The Glitch & The Fix: One size doesn't fit all April 2023

The Glitch:

Figure 1

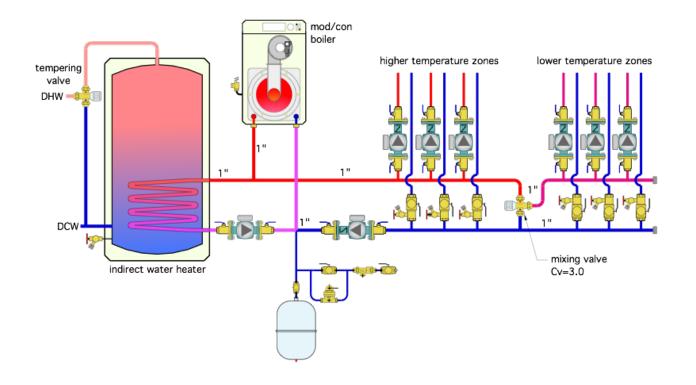
- 1. If the total design flow rate is 6x4 = 24 gpm, the 1-inch header piping is grossly undersized. Its use will likely create a high pressure drop when all zone circulators are operating. The undersized piping will also create more hydraulic interference between simultaneously operating circulators;

- 2. The circulator labelled (P2) is in series with the zone circulators. The mod/con boiler requires a dedicated circulator that is hydraulically separated from the zone circulators;

- 3. There is no central air separating device in the system;
- 4. The purging valves are installed upside down;
- 5. The expansion tank is very close to the outlets of circulators (P1) and (P2);

- 6. The inlets of the zone circulators are shown very close to the header. This creates turbulence at the eye of the impellers, which could induce cavitation. There should be at least 12 pipe diameters of straight pipe on the inlets side of all circulators;

- The 1-inch tempering valve with Cv=3.0 is grossly undersized to supply 3 zone circulators at 4 gpm each. Pushing 12 gpm through a valve with a Cv of 3.0 would require about 16 psi. That's much higher than any residential zone circulator can manage. A mixing valve with a Cv of approximately 12 would be the proper selection;

- 8. The DHW circulator lacks a check valve. Without it, there will be some reverse flow through the coil of the indirect water heater when the space heating portion of the system is operating; and

- 9. A mod/con boiler serving 6 zones is likely to experience short cycling when only one zone is on.
